<b>Hillrom™</b> Hillrom Luleå Nedre Vägen 100, 975 92 Luleå, Sweden	<b>Field Safety Notice</b>	<b>FA 2021-05-002-LUL-003</b>
---	----------------------------	-------------------------------

**Field Action Identifier: FA 2021-05-002-LUL-003**

OctoStretch with Stretch Leveller, FlexoStretch, Stretch Leveller, LikoStretch 1900, Liko Stretch Mod 600 IC.

Fig 1:

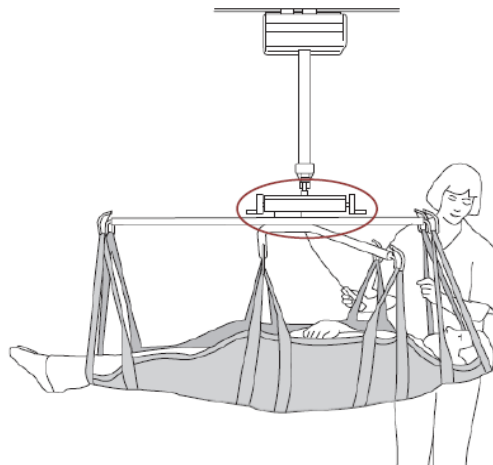
Hillrom has become aware of a user report of Leveller breakage used with the Octo Stretch.

As a result of the breakage the Stretch Leveller has the potential to lose the function of maintaining a patient in the horizontal position when lifting and in motion. When this function is lost the patient can slide backwards and potentially may fall out of the Oct lift sheet back onto the surface it is being lifted from. See Figure 1: OctoStretch with Leveller in use, Stretch Leveller circled.

Hillrom is replacing the stretch leveller to mitigate this risk of breakage. Upon completion of the enhancement(s), Hillrom will contact customers to coordinate update of the leveller device.

Fig 2:

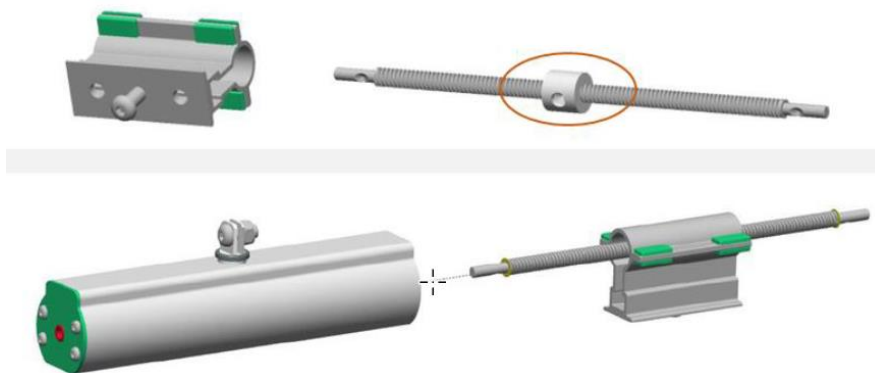
The function of the Stretch Leveller connected to the OctoStretch is to allow for adjustment of the center of gravity during lift. The Stretch Leveller is composed of a trapezoidal nut attached to an attachment profile on a threaded rod. If the trapezoidal nut breaks the leveller can shift center of gravity without the user activating the function, causing the stretcher to tilt unexpectedly. See Figure 2: Main components and assembly of Stretch Leveller. Trapezoidal nut circled.
